TECHNICAL MEMORANDUM

To: Lake County Community Development Department

From: Annjanette Dodd, PhD, CA PE #77756

Subject: Seigler Springs North – UP 21-17– Revised Project Information and Response to Review of May 2023 Hydrology Report prepared for UP 21-17

Figure 1. Estimated radius of influence (distance) associated with the project's well (Threshold = 6-inches).

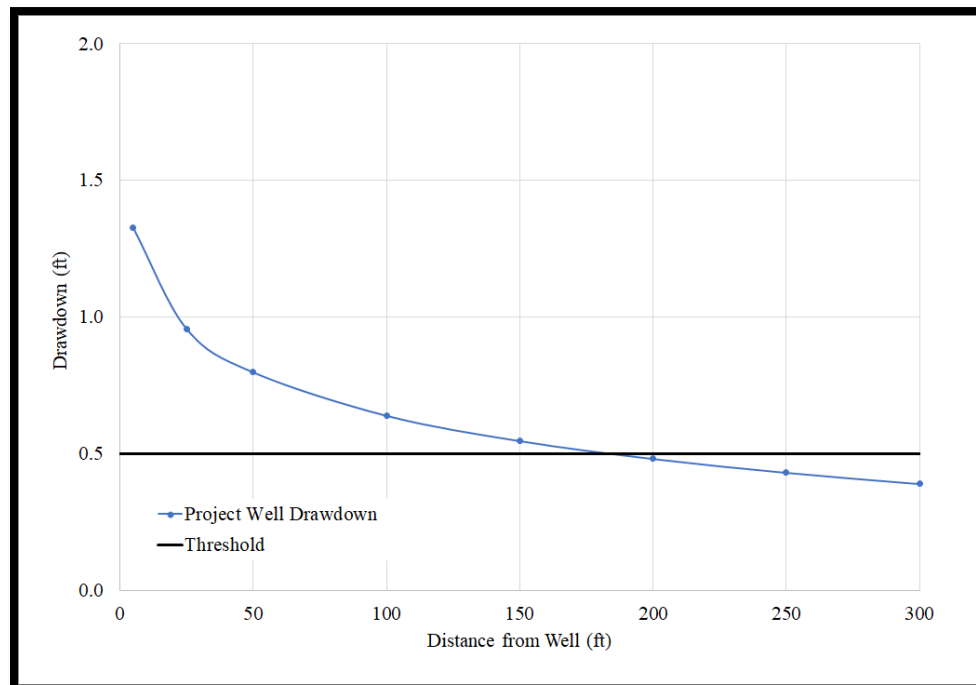
Geosyntec Comment #5: An adequate assessment of cumulative impacts to other water uses in the area was not provided. To provide an accurate assessment of cumulative impacts to the surrounding area, first the orientation and dip of the producing fractures must be known. This information can be obtained by use of the optical televiwer and heat pulse flow meter discussed for Comment 3. For example, if the producing fractures trend towards the northeast or southeast, then pumping on the proposed project well could have significant impact to the existing wells at the Mountain of Attention property.

Per Geosyntec's comment letter, The Mountain of Attention Sanctuary operated by the Adidam Holy Domains has multiple wells and the nearest well operated by the Mountain of Attention is located 2,921 feet to the west of the proposed project. The radius of influence of the project well was estimated using the Theis equation (Fetter, 2001). The Theis equation was developed to model the response of a confined aquifer to pumping. Using the Theis equation, the drawdown at a specific distance from each well can be estimated based on the project's maximum irrigation pumping

Geosyntec Comment #5 Continued: In addition, until assessments are made on what the actual well capacity and aquifer recharge values are, operation of this well could dry out fractures in the area also resulting in significant impacts to nearby groundwater wells. Anecdotal information already suggests that fractures may be drying out and not being recharged. Attachment 4 provides two reports from adjacent properties. The first report is a summary of operations of four existing wells at the Mountain of Attention (Figure 1). As indicated in this report, pumping conducted years ago on a specific well (date not specified), supplied 80 gpm, 24-hours a day, 7-days a week. For a test conducted in July 2021, this well only supplied water at 80 gpm 6-hours a day before the well went dry. The well did recharge so that it could be pumped the next day. The second report is a memo from Timothy Toye, a local real estate broker, who indicates knowledge of two wells in the area that have dried up. Both of these reports strongly suggest that the system is being over pumped and not allowing recharge to occur.

demand, 10 gpm, over a duration of 22 hours (Attachment 4). The radius of influence is the distance where the modeled cone of depression from groundwater extraction (drawdown) under these conditions is negligible (less than 6-inches), which is less than 200 feet from the project well (Figure 1), over 2,700 ft (0.5 miles) from the Mountain of Attention Sanctuary wells.

Response: Attachment 4 referenced by Geosyntec does provide enough information regarding the wells at Mountain of Attention and why they went dry. There are many reasons a well can go dry, construction issues, over pumping, maintenance, seasonal fluctuations, pump installation level, location, etc. Of the four existing wells at the Mountain of Attention, the report indicated that the other three wells are still working and providing water. Also, the wells are over 2,700 feet away from the project well. The information provided does not provide evidence that the project well would go dry. In addition, as discussed previously, the project proposes continuous groundwater level monitoring.

Figure 2. Screened well interval (SI) elevations and ground surface elevations.

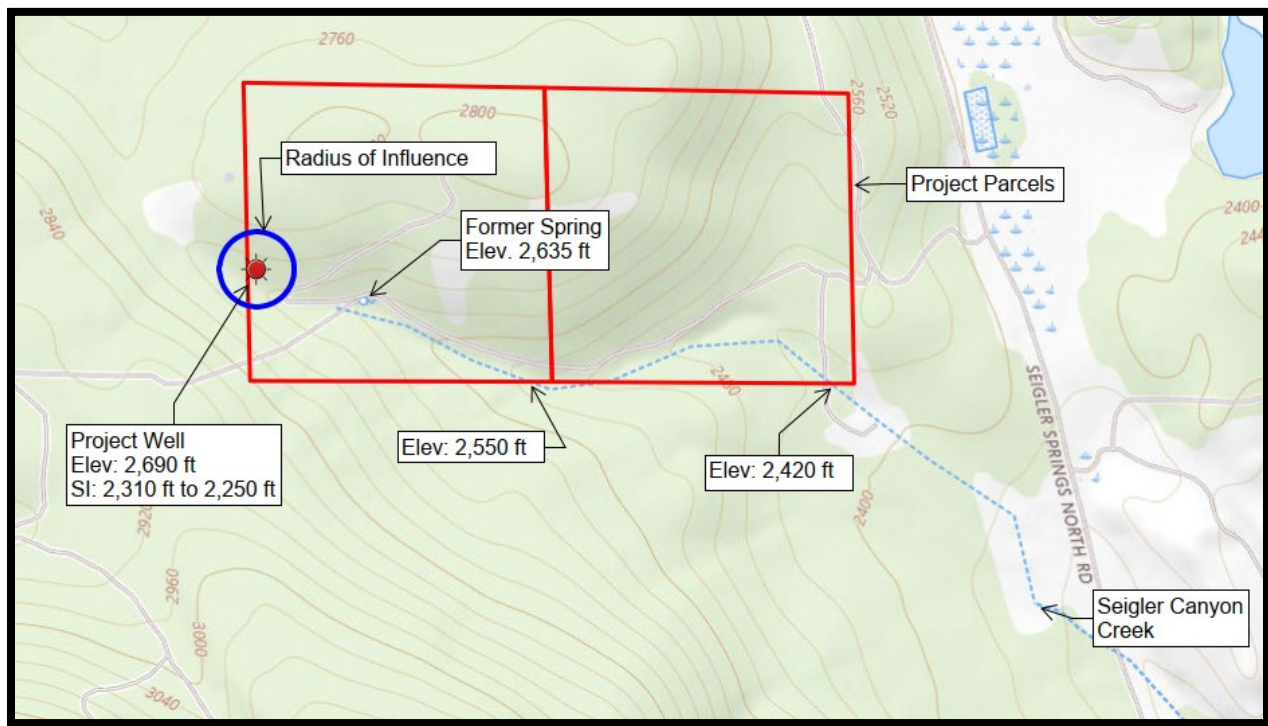
Geosyntec Comment #5 Continued: The report also did not assess the presence of springs in the area that could be sourced from this aquifer system. A map showing where springs are located and study to assess potential impacts to these features needs to be completed and if impacts affect surface water flows. In addition, the geologic map provided in the Northpoint report indicates there are faults in the area including one that goes through the project area. The impact on water movement from these faults should be assessed for this project.

Response: The USGS topographic maps indicate a spring approximately 500 feet west of the well. The Biological Resources Assessment prepared by Natural Investigations (dated November 2020) for the project did not identify any springs on site and stated that, “a spring is indicated on the USGS topo map, but no spring could be found at the top of the watercourse”. That being said, the location of the spring is located outside of the radius of influence of the well. The surface elevation of the spring is approximately 325 feet above the screened interval of the well, which starts at an elevation of approximately 2,310 ft and ends at an elevation of approximately 2,250 ft, well below the elevations of the ephemeral streams in the vicinity of the project parcels (Figure 2). The project well extracts water from a confined volcanic water bearing unit, well below surface water, and is a non-diversionary water source.
